NOTICE OF FILING SECOND REVISED SUPPLEMENTAL EXHIBIT PJR-13

SECTION 10.3 UNDERGROUND DISTRIBUTION FACILITIES FOR
RESIDENTIAL SUBDIVISIONS AND DEVELOPMENTS

Docket Nos. 080244-EI and 070231-EI
Recommended URD Changes
Supp. Exh. _____ (PJR-13)
2nd REVISED - May 8, 2009
Page 1 of 4

CIAC Distribution Low Density

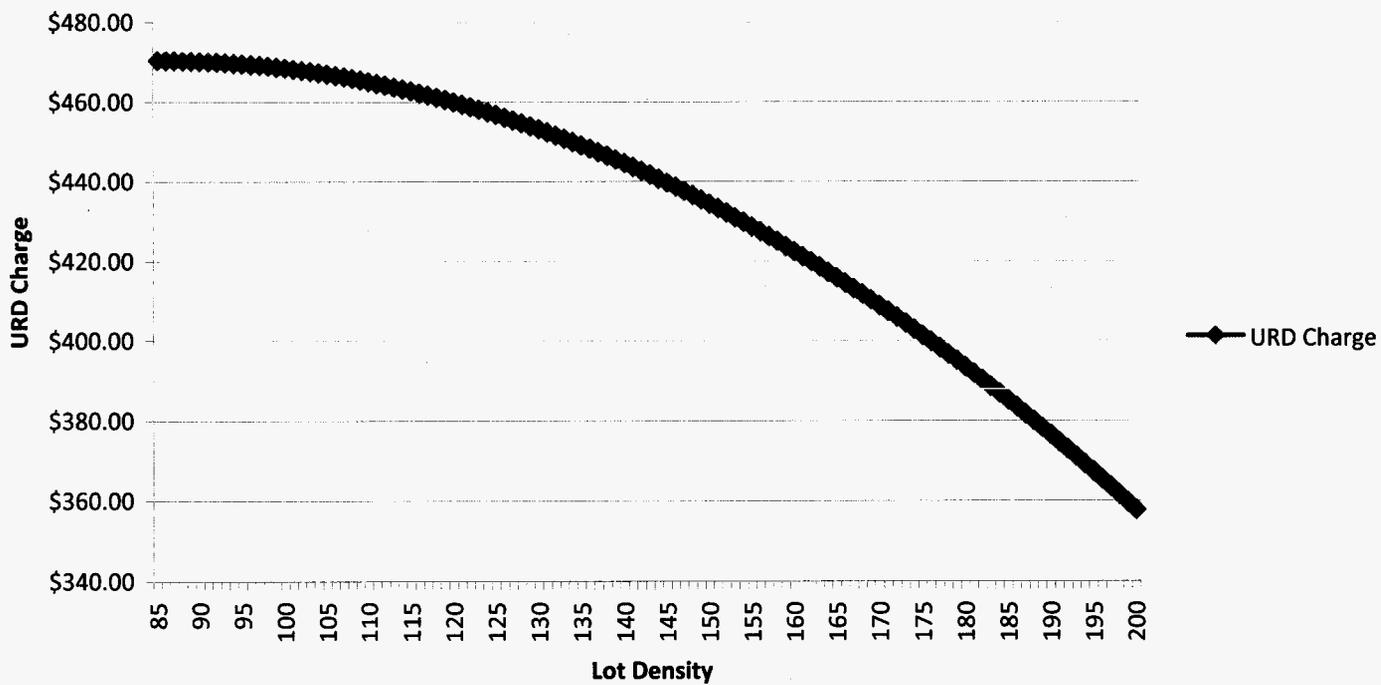
analysis. The SECOND REVISED Exhibit PJR-13 corrects the titles of the vertical axes in the graphs that comprise page 3 of 4 and page 4 of 4 of the Exhibit; in the previous versions, these were inadvertently labeled "URD Credit," whereas they should have been labeled "URD Charge." The corrected labeling is consistent with the values and formulas shown in the Exhibit. The content shown on pages 1 of 4 and 2 of 4 of Exhibit PJR-13 remains unchanged from the revised versions that were filed on May 7, 2009, but the headers on these pages have also been re-dated in an effort to avoid ambiguity, such that all 4 pages bear the same revision date, i.e., May 8, 2009.
